## DOVER PLANNING BOARD – AGENDA

Meeting Type: Regular Meeting  
Meeting Location: Council Chambers, City Hall, 288 Central Ave, Dover NH 03820  
Meeting Date: **Tuesday, October 26, 2021**  
Meeting Time: **7:00 pm**

- C. Consideration and acceptance of a Site Review for Atlantic Broadband, (Owner: Quantum Real Estate Group, LLC), Assessor's Map H, Lot 29A-1, zoned CM, located at Littleworth Road. (Proposal is to construct a 924 sq. ft. Public Utility Building with associated parking, utilities and drainage improvements). \*(P21-63)

**SP-1**

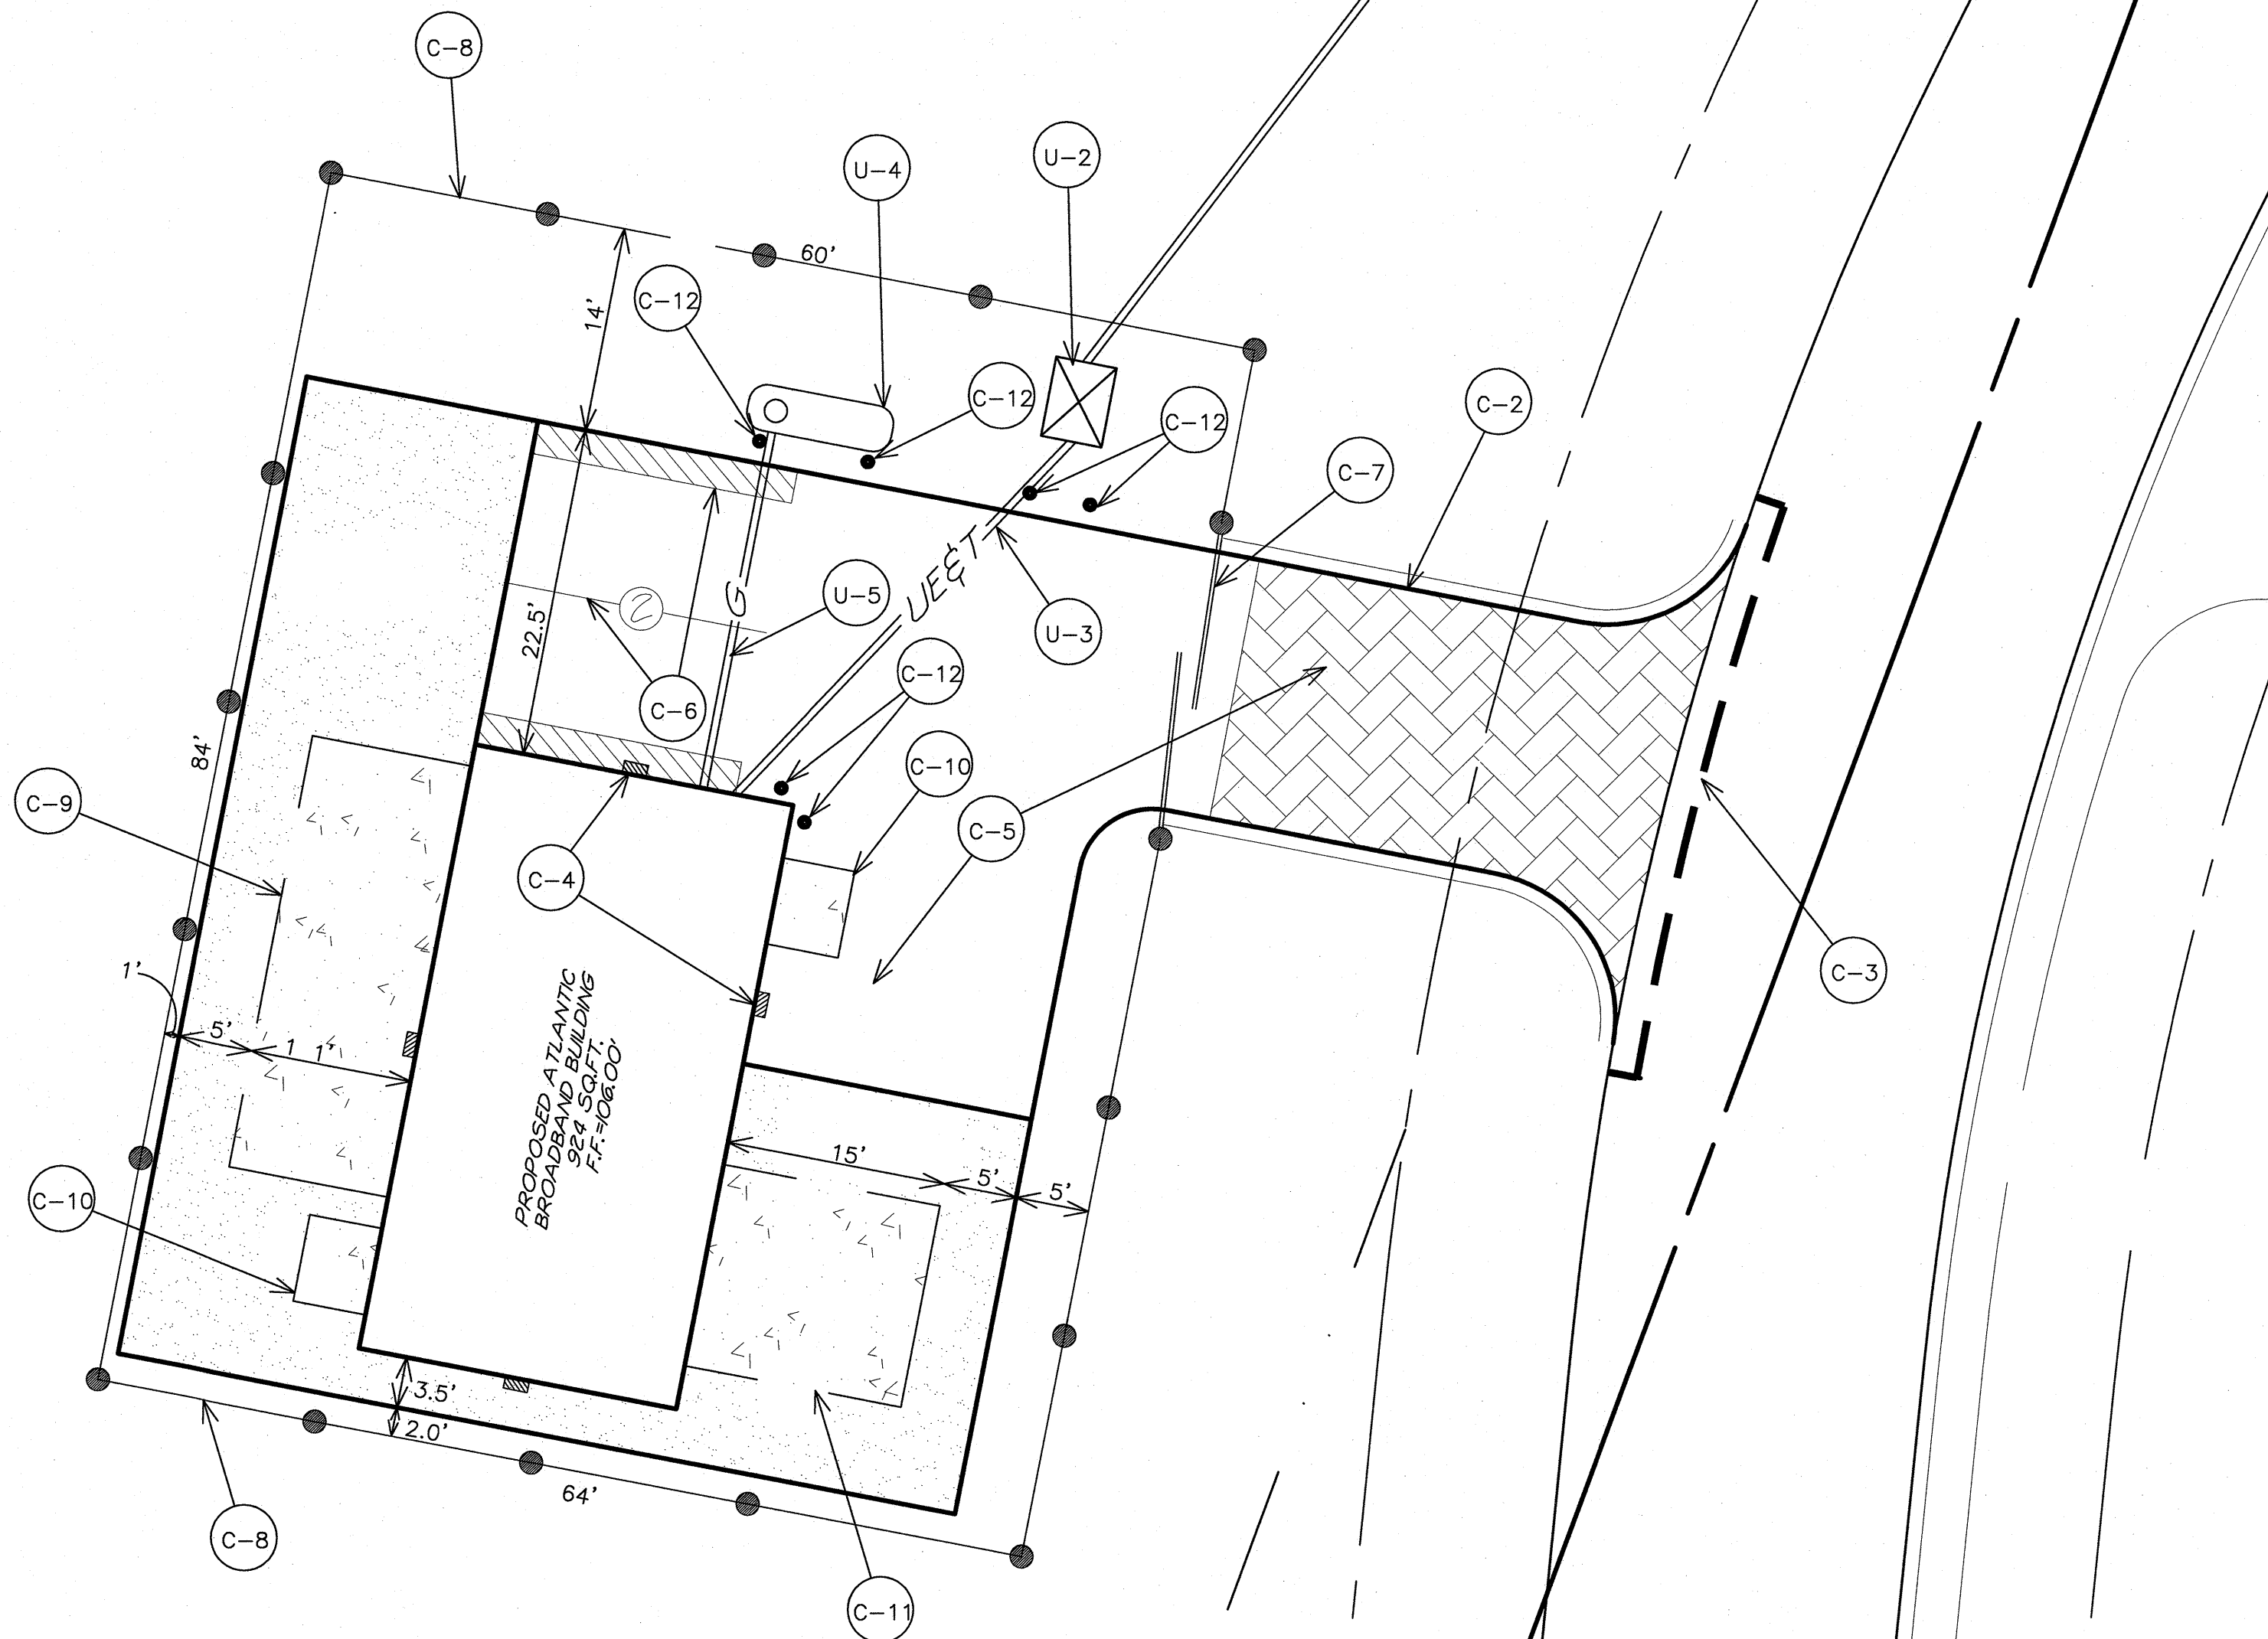
- Impact Fees: \$582.12  
*The Applicant is aware of these fees.*
- **Revise Plan Set to add:**
- Missing Common Site Plan Notes # 7, 10, 24, 31, 32, & 37.  
*Common Site Plan Note 7 can be found as Notes #16 & 17, Sheet SP-1.*  
*Common Site Plan Note 10 can be found as Note #8, Sheet SP-1.*  
*Common Site Plan Note 24 can be found as Note #18, Sheet SP-1.*  
*Common Site Plan Note 31 can be found as GC Note #25, Sheet SP-2.*  
*Common Site Plan Note 32 can be found as Note #19, Sheet SP-1.*  
*Common Site Plan Note 37 is not applicable City water is not proposed for this project*

**LA-1**

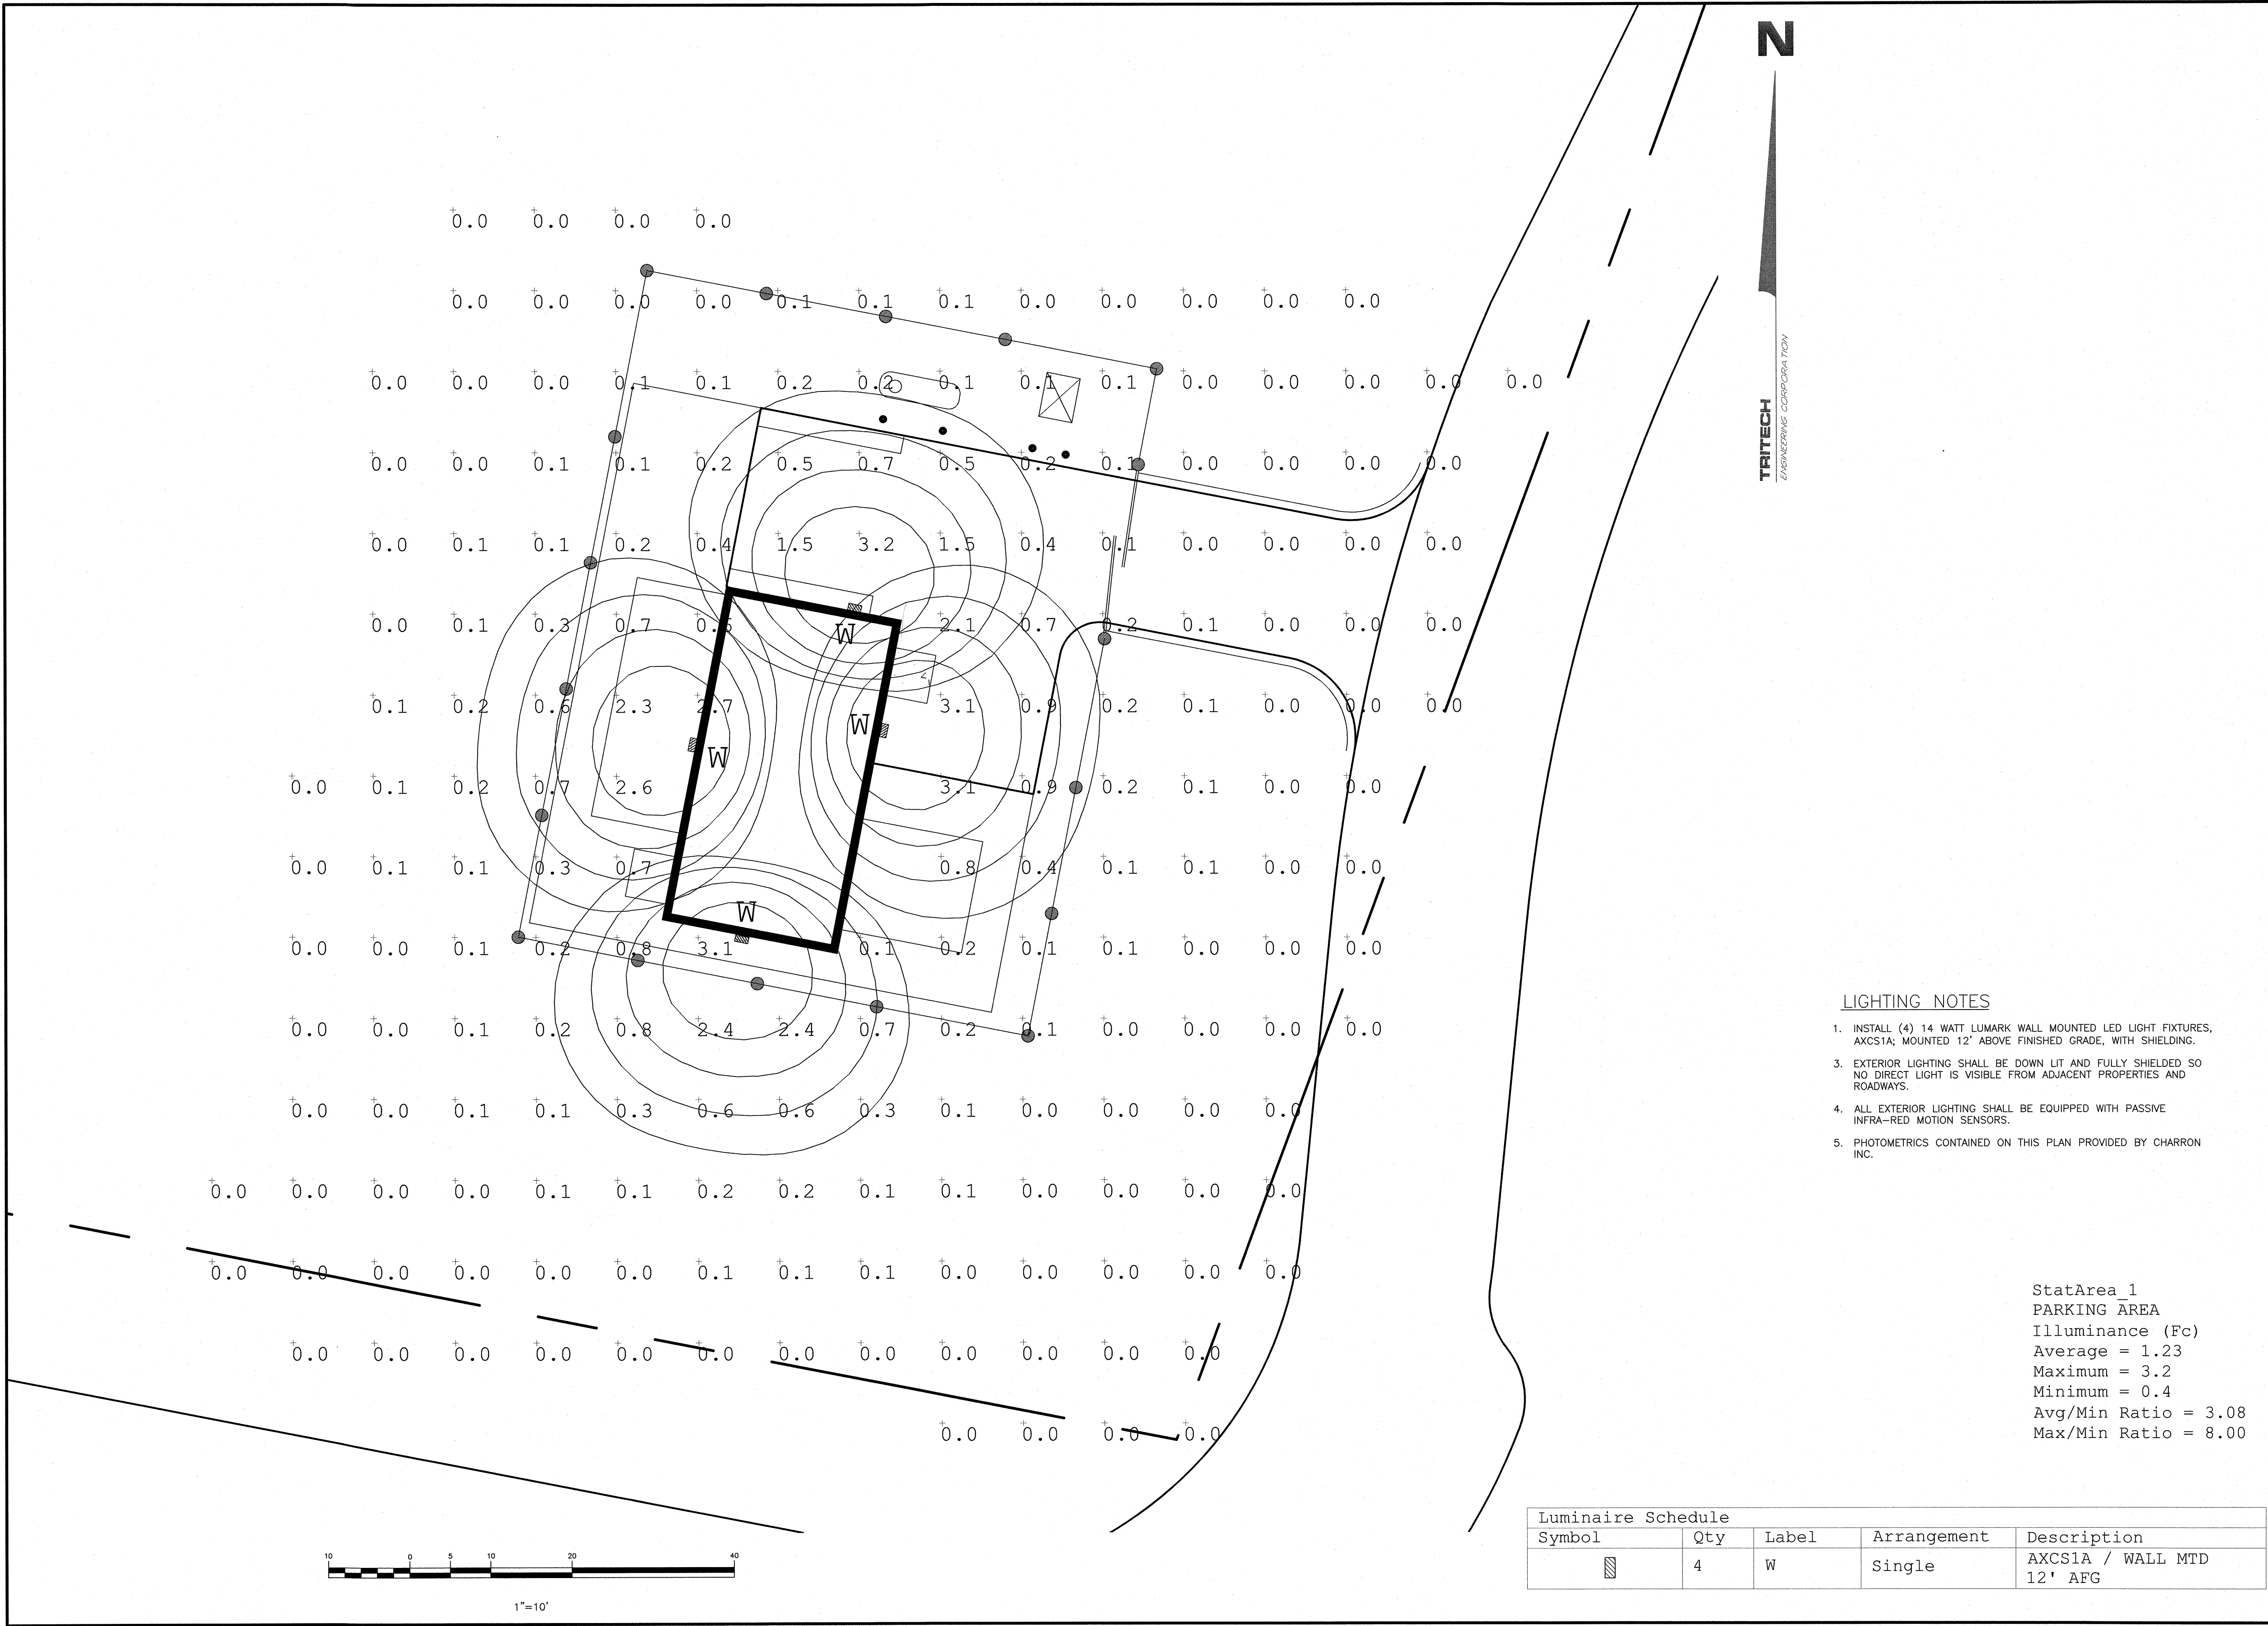
- Include File # P21-63 on each plan sheet.  
*File Number P21-63 has been added to all sheets as requested.*
- Landscape Architect signature  
*Landscape Architect signature has been added to Sheet La-1 as requested.*

Li-1

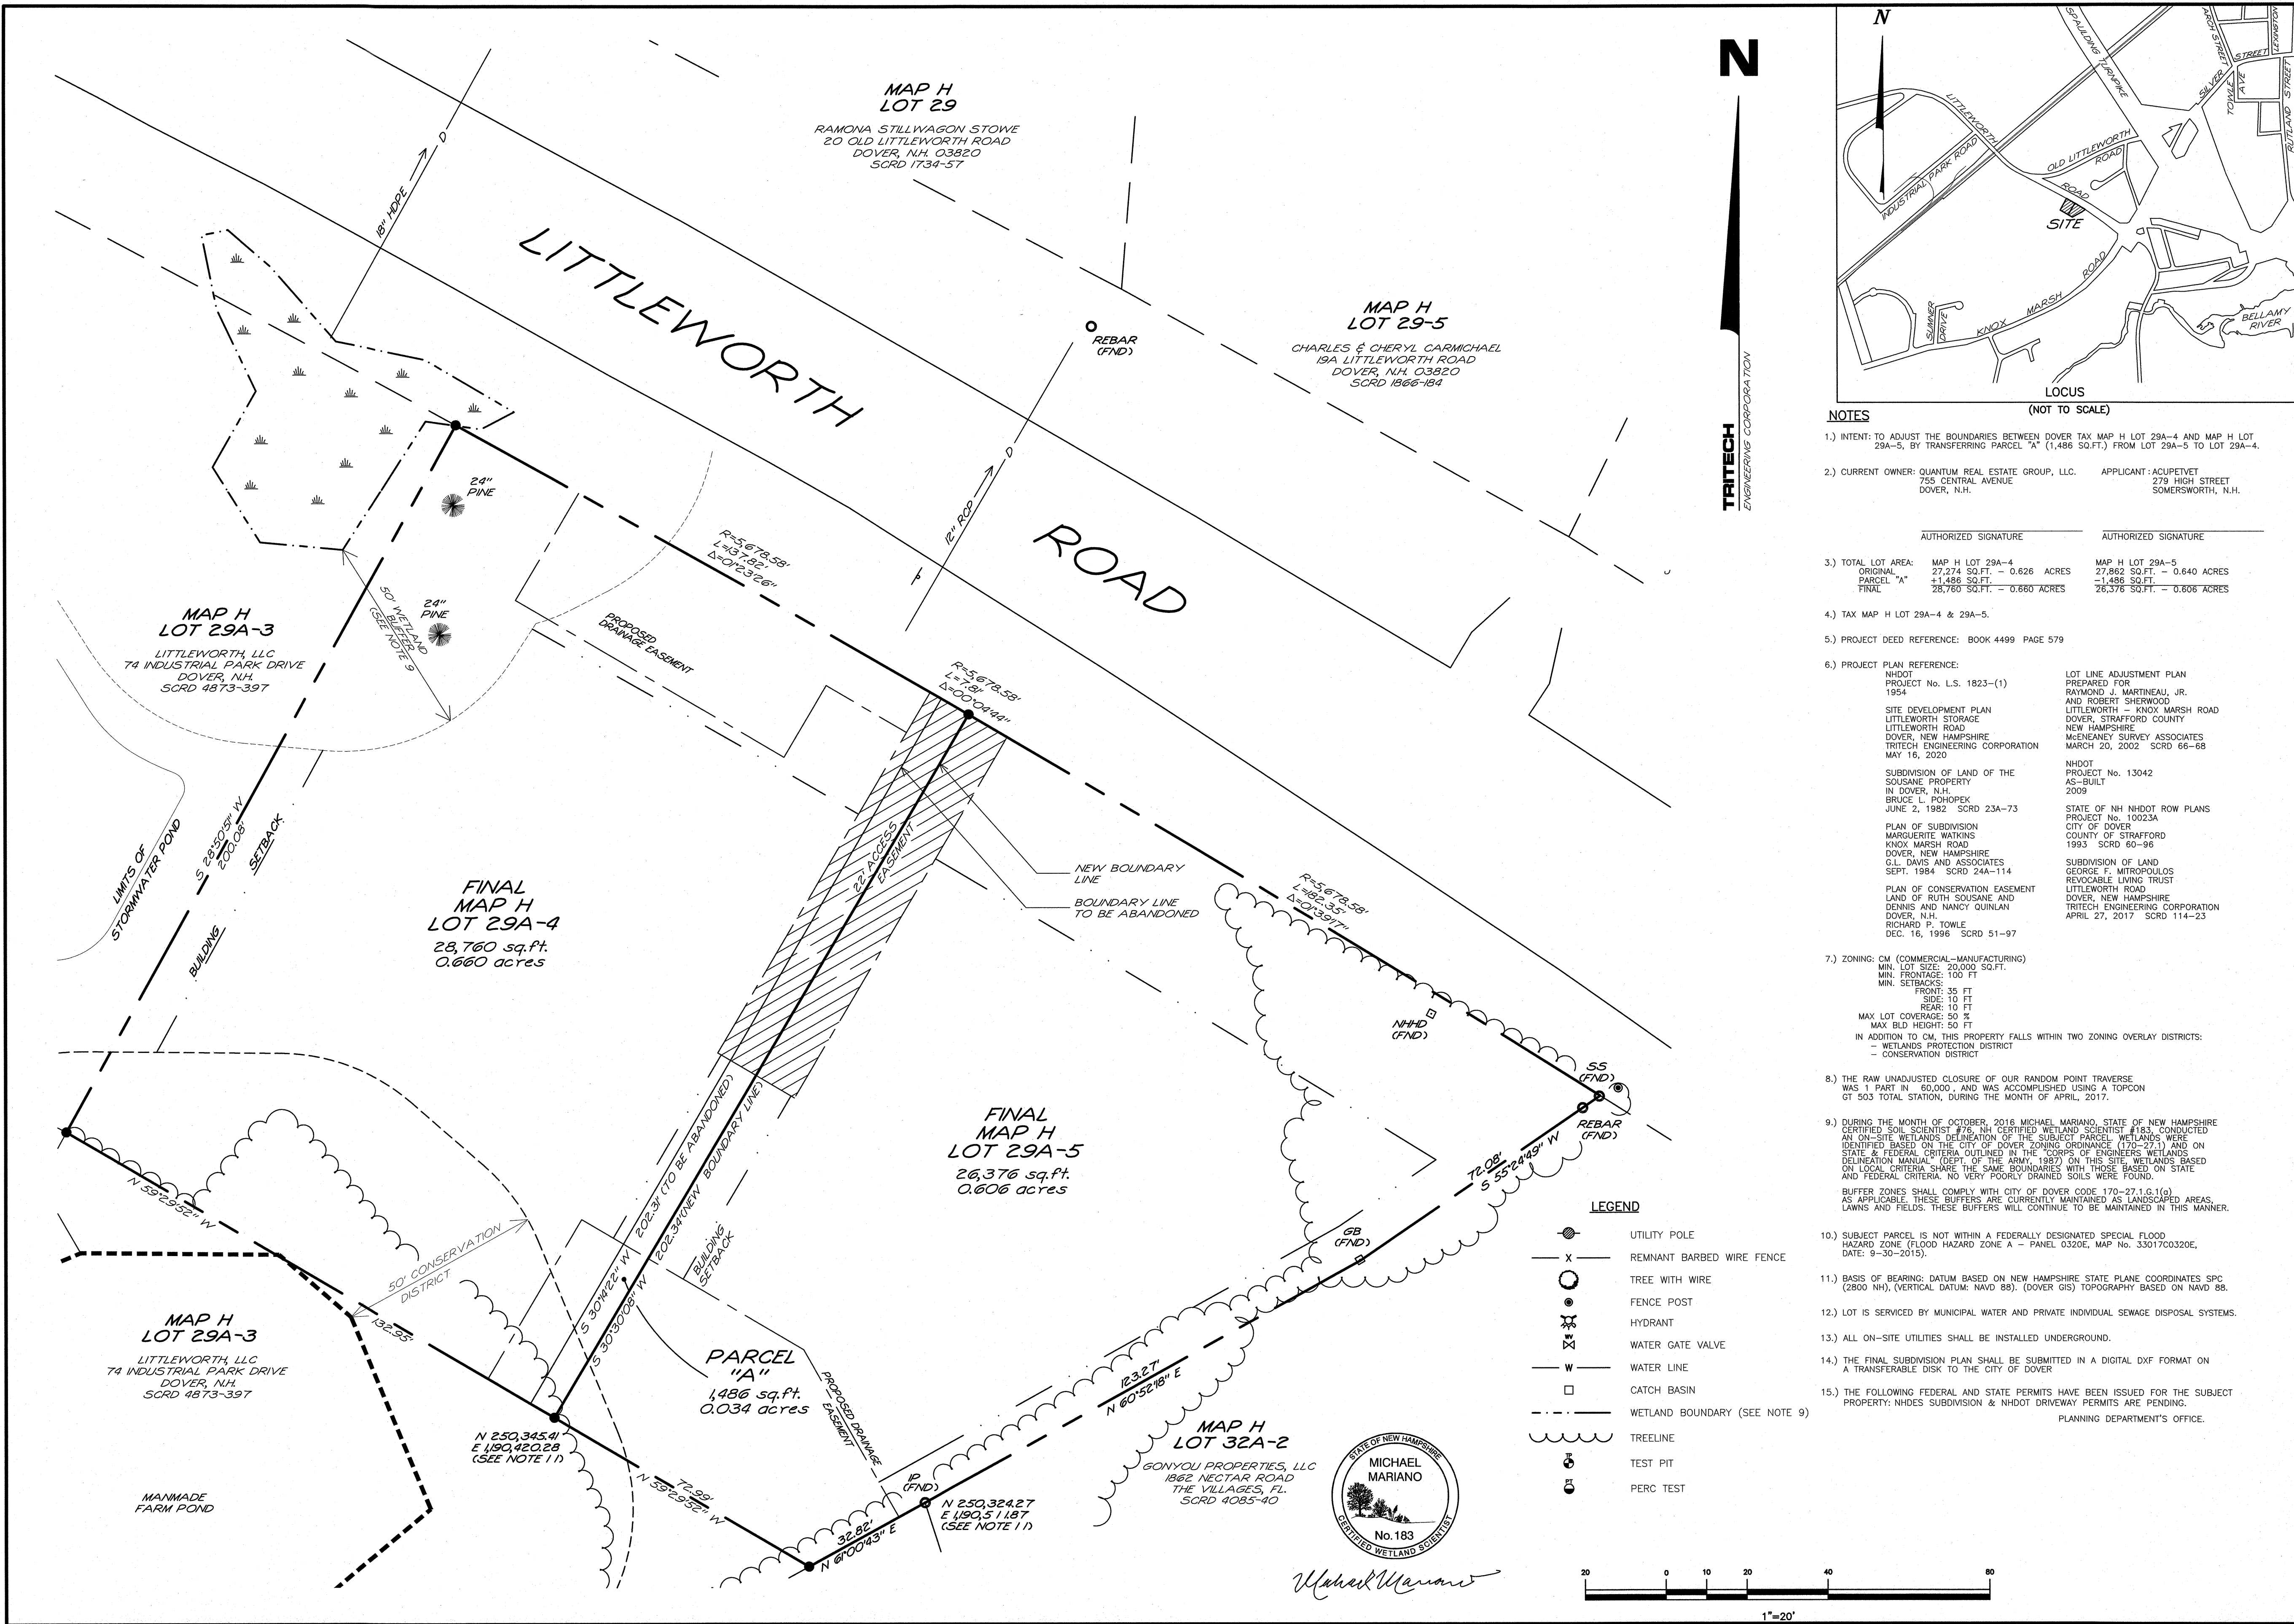
- Add security lighting on all 4 sides of building.  
*Security Lighting has been added as requested. See Sheet Li-1 for photometrics.*
- Streetscape needs to include/match landscape plan  
*The streetscape has been revised as requested.*
